**Addendum No. 3**  
Page 1 of 21

Joliet Junior College  
1215 Houbolt Road  
Joliet, IL 60431

**TO:** Prospective Respondents  
**SUBJECT:** Addendum No. 3  
**PROJECT NAME:** Renaissance Center Interior Renovations  
**JJC PROJECT NO.:** B16008

SHEET NUMBER:  
**FP1.20**

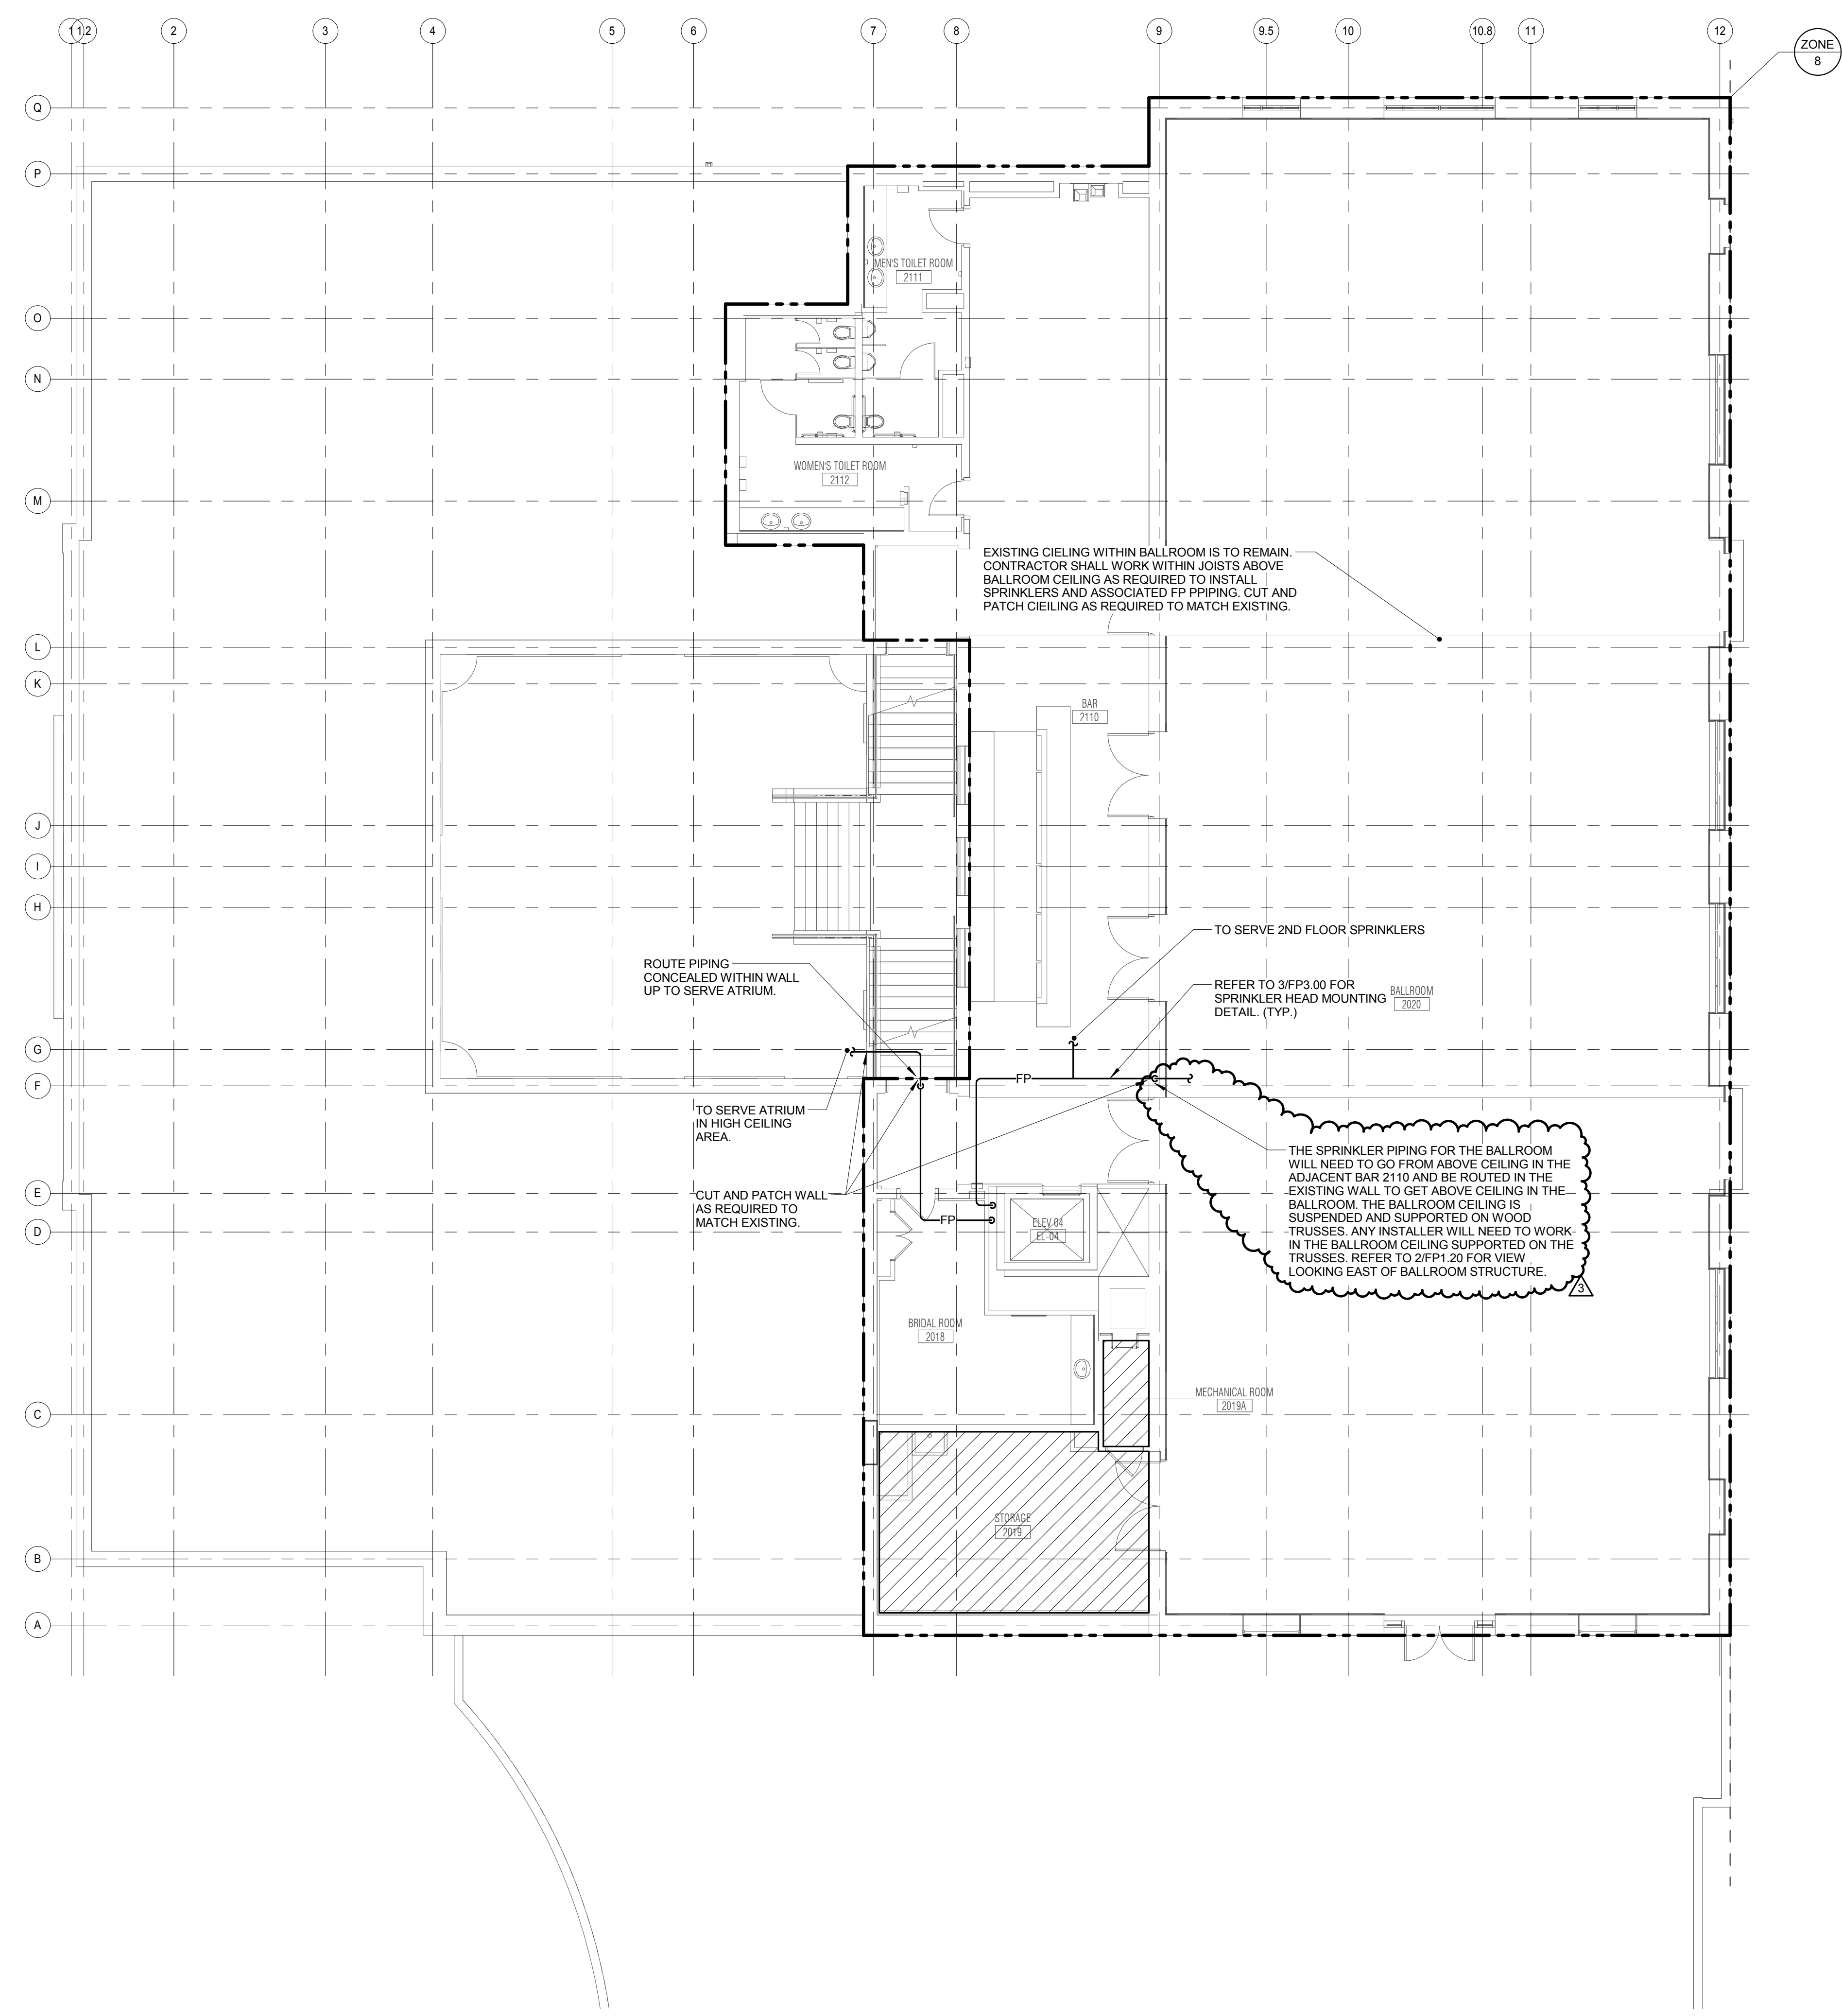
- A. Drawing FP1.20 **Add** note and picture to show structure above ballroom ceiling. Refer to FP1.20 for additional information.

***The sprinkler piping for the ballroom will need to go from above ceiling in the adjacent Bar 2110 and be routed in the existing wall to get above ceiling in the ballroom. The ballroom ceiling is suspended and supported on wood trusses. Any installer will need to work in the ballroom ceiling supported on the trusses. Refer to revised fire protection sheet FP1.20 for more information and photos of existing structure.***

SHEET NUMBER:  
**E2.20**

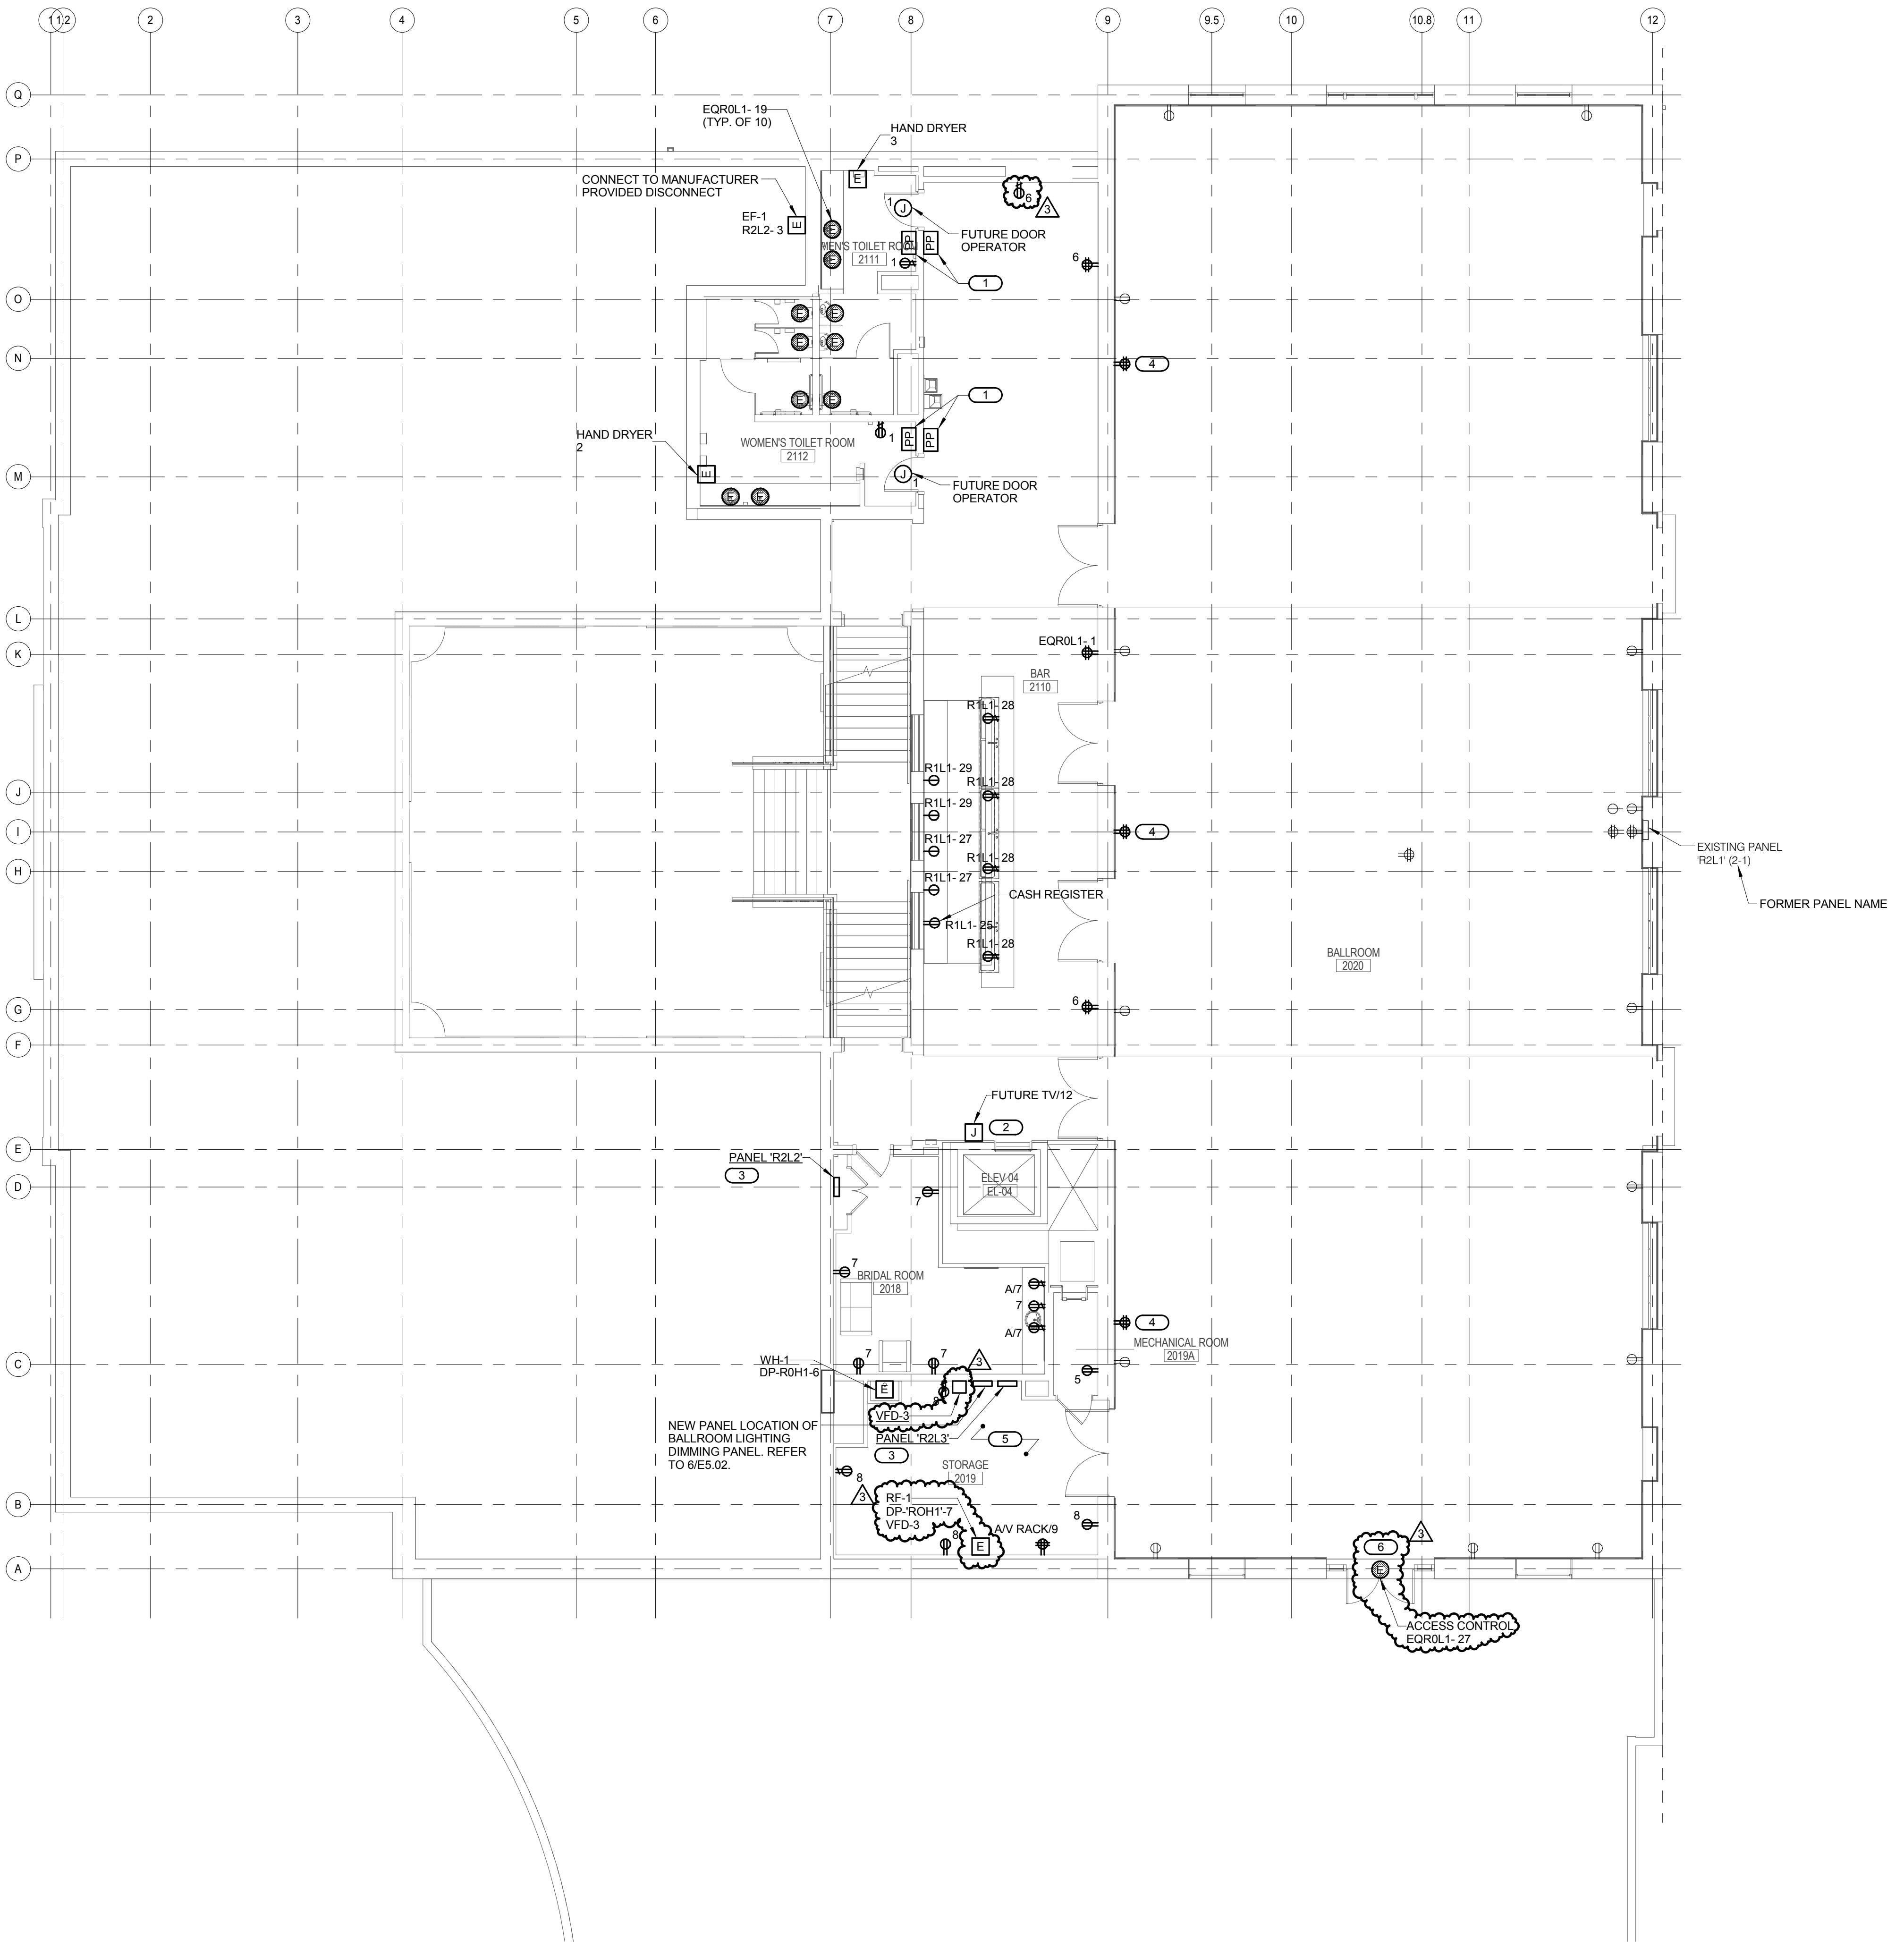
- i. **Add** electrical connections for Access Control in Flex Space 1037, Flex Space 1029, and Classroom 1030.
- K. Drawing E2.20:
- a. **Add** electrical connection for RF-1 and **add** VFD-3 in Storage 2019.

- b. **Add** electrical connection for Access Control in Ballroom. **Add** keynote #6.
  - c. **Add** GFCI receptacle for DF-1 in Bar 2110.
- L. Drawing E2.30:

A111-01

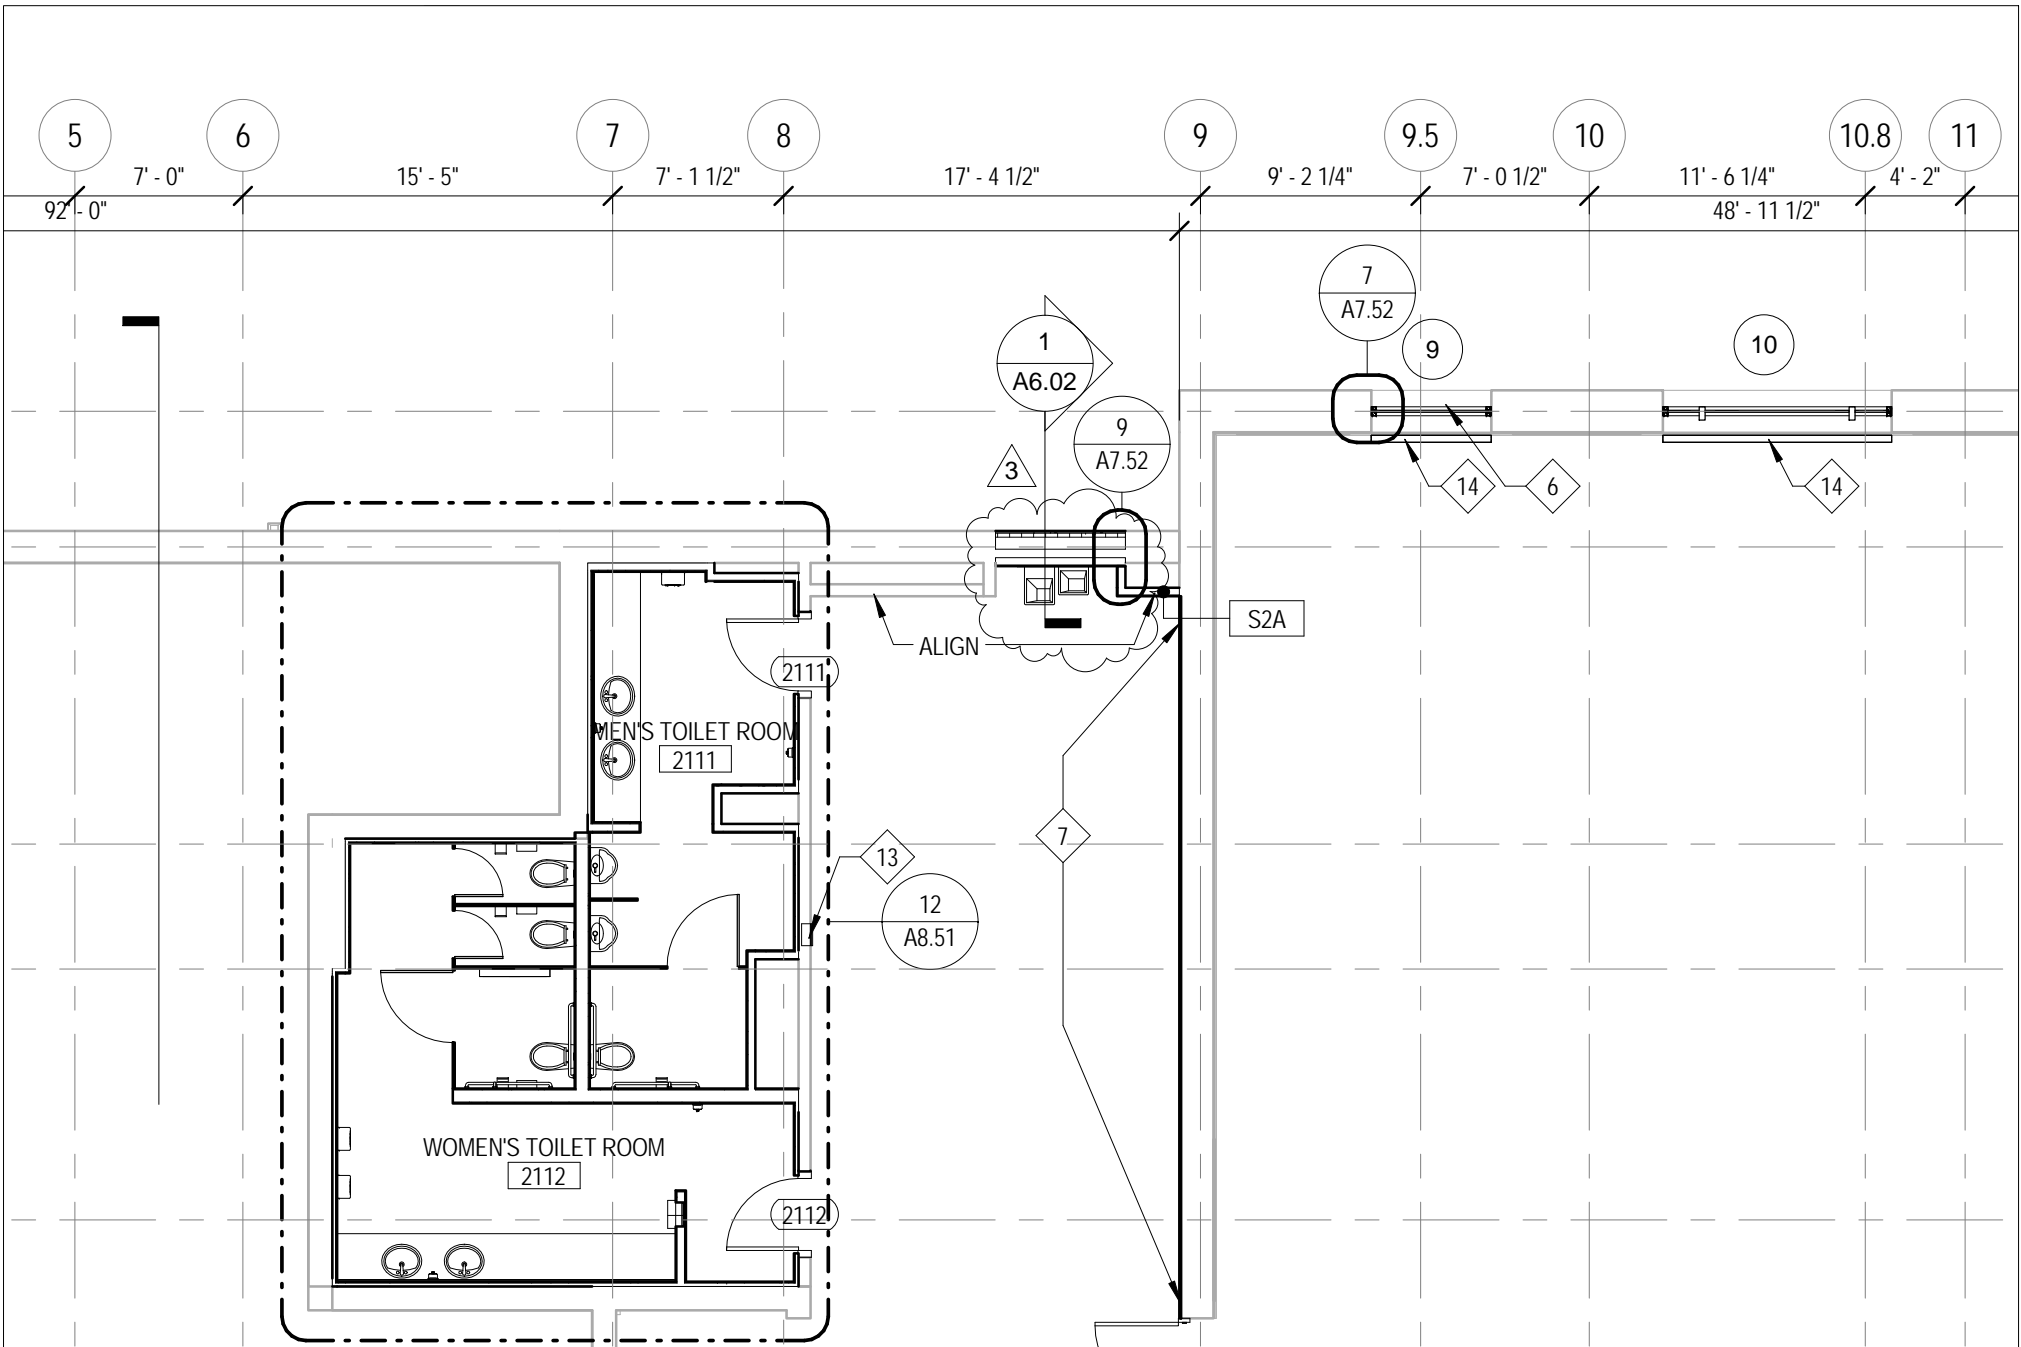
- 2) **ADD** general note 5. to read "CONTRACTOR IS RESPONSIBLE FOR THE SAFE REMOVAL OF BULDING STRUCTURAL SYSTEM."
- F. Sheet A1.11: **REVISE** per attached sketch **A111-01**
